Re: Technical Corrections Review: Everlea – Master Plan with Adjustments
Application Number: DA-2337-00
Case Number: 2022-7005-00

Technical Corrections Review

TAB 8: LAND USE MAP AND MATRIX

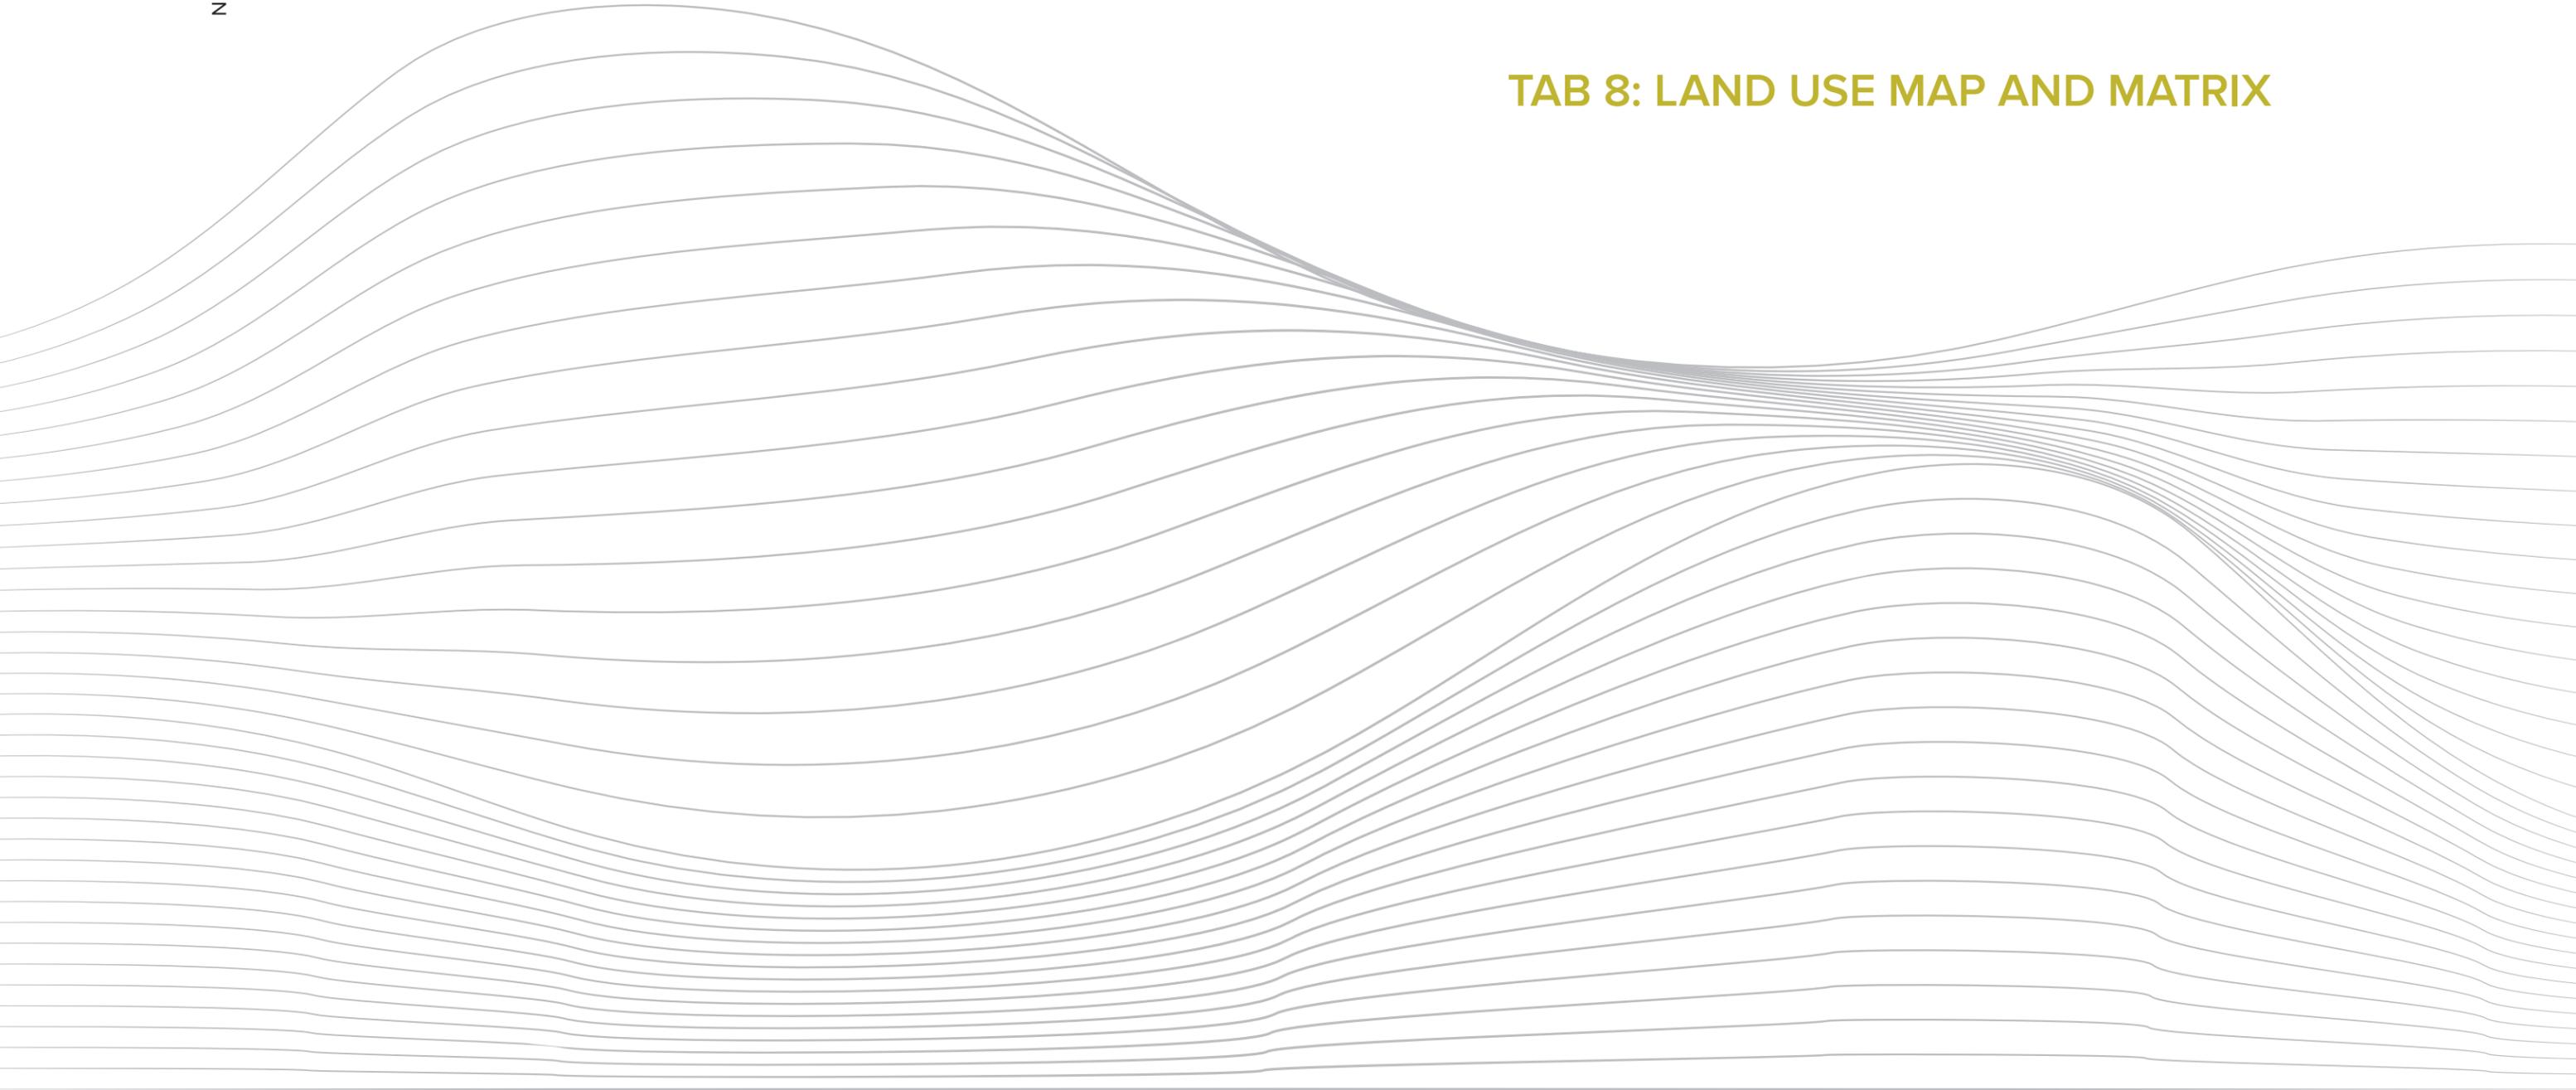
Update all numbers per comments in the Tab 9.

Update all numbers per comments in the Tab 9. Please ensure numebrs are consistnet across tabs.

RESPONSE: CHART AND NUMBERS HAVE BEEN UPDATED TO ALIGN WITH TAB 9

RESPONSE: CHART AND NUMBERS HAVE BEEN UPDATED TO ALIGN WITH TAB 9

TAB 9: OPEN SPACE, CIRCULATION, AND NEIGHBORHOOD PLAN

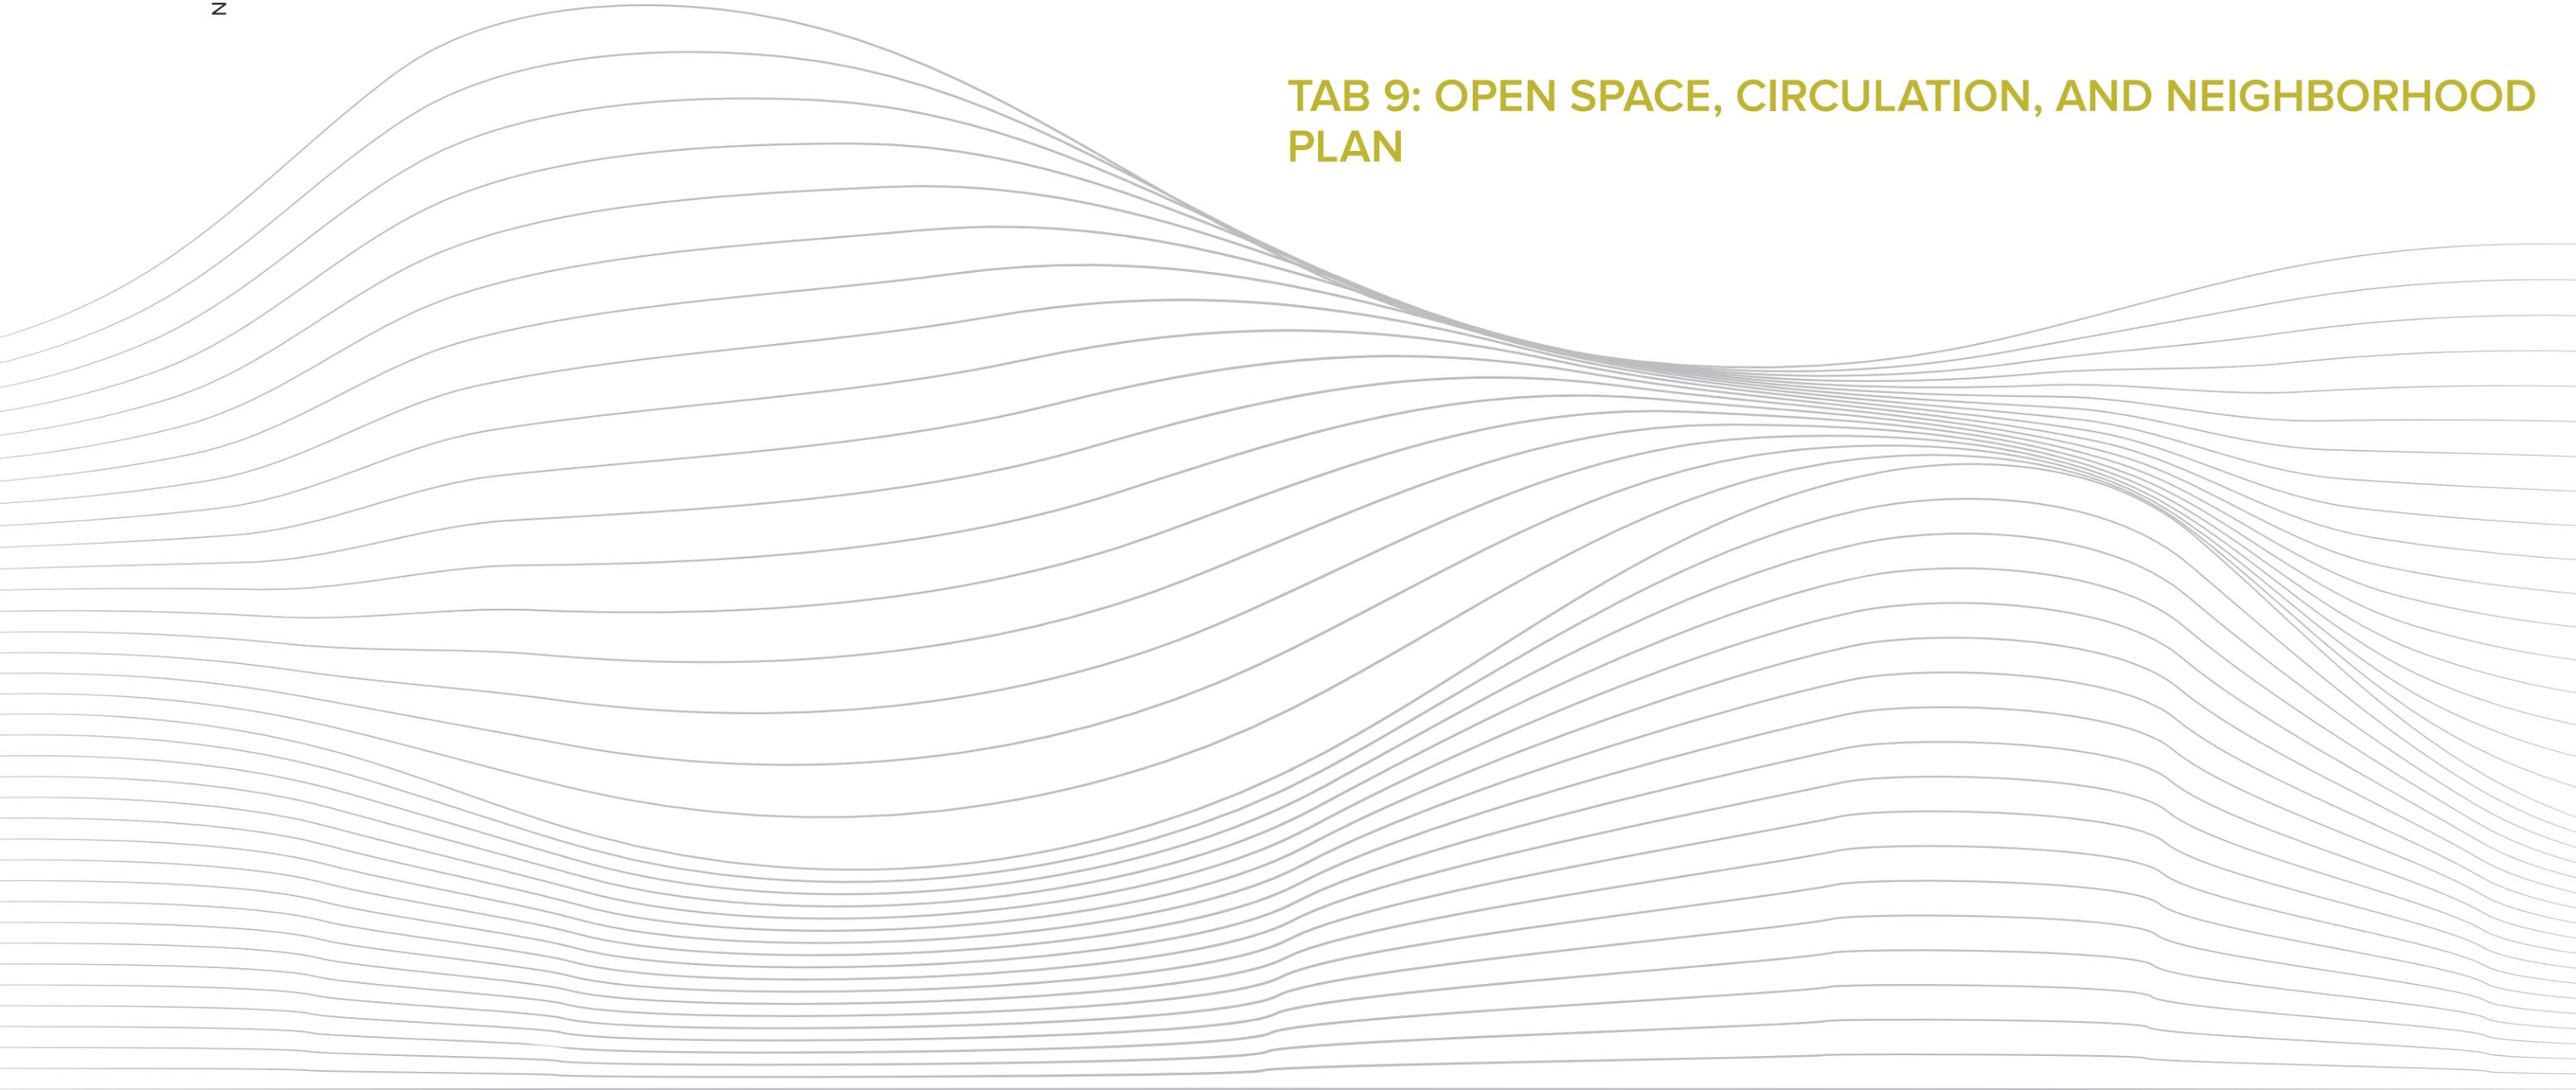
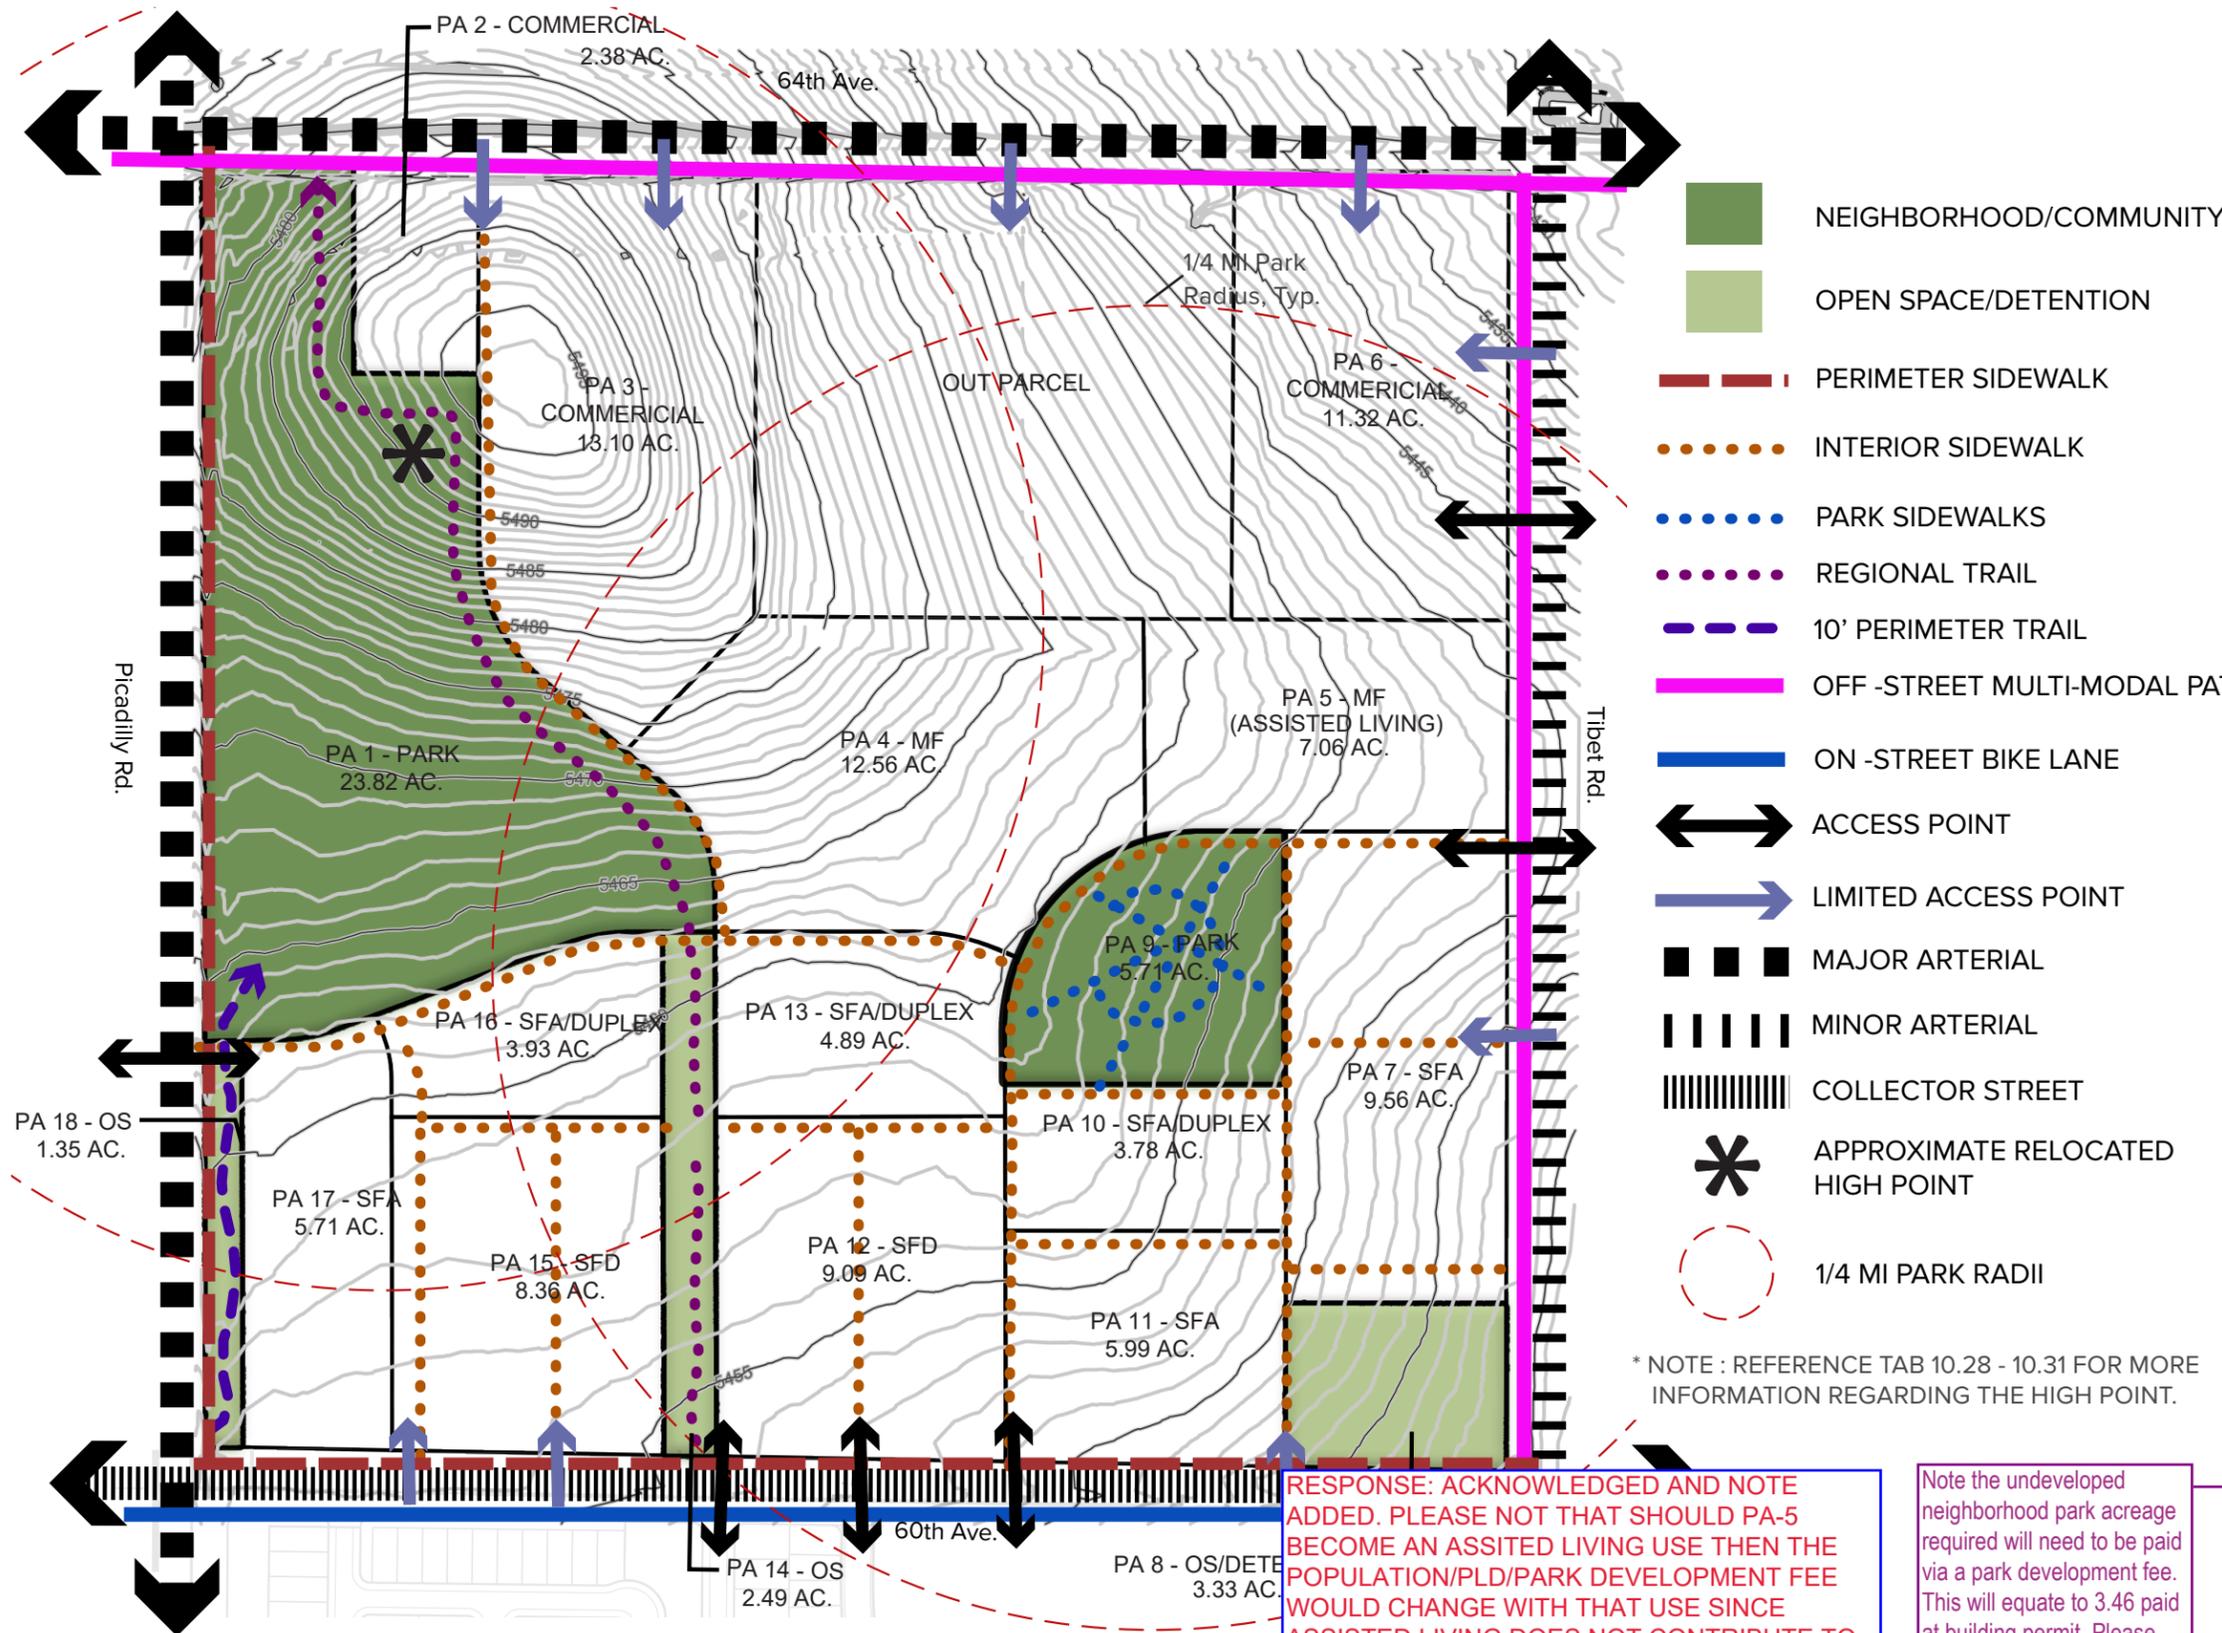
This table is not accurate based on the updated unit counts. For 1064 units and a total population of 2729 the following is required:
 8.19 neighborhood park
 3.0 Community Park
 21.28 open space

Note the undeveloped neighborhood park acreage required will need to be paid via a park development fee. This will equate to 3.46 paid at building permit. Please include note.

Prior to mylar, please discuss with PROS the timing for the land dedication to the city. (note no trigger for completion of the park should be included as that will be per city approval)

RESPONSE: TABLE AND NUMBERS HAVE BEEN UPDATED

RESPONSE: ACKNOWLEDGED AND NOTE ADDED. PLEASE NOT THAT SHOULD PA-5 BECOME AN ASSITED LIVING USE THEN THE POPULATION/PLD/PARK DEVELOPMENT FEE WOULD CHANGE WITH THAT USE SINCE ASSISTED LIVING DOES NOT CONTRIBUTE TO PLD..

RESPONSE: ACKNOWLEDGED
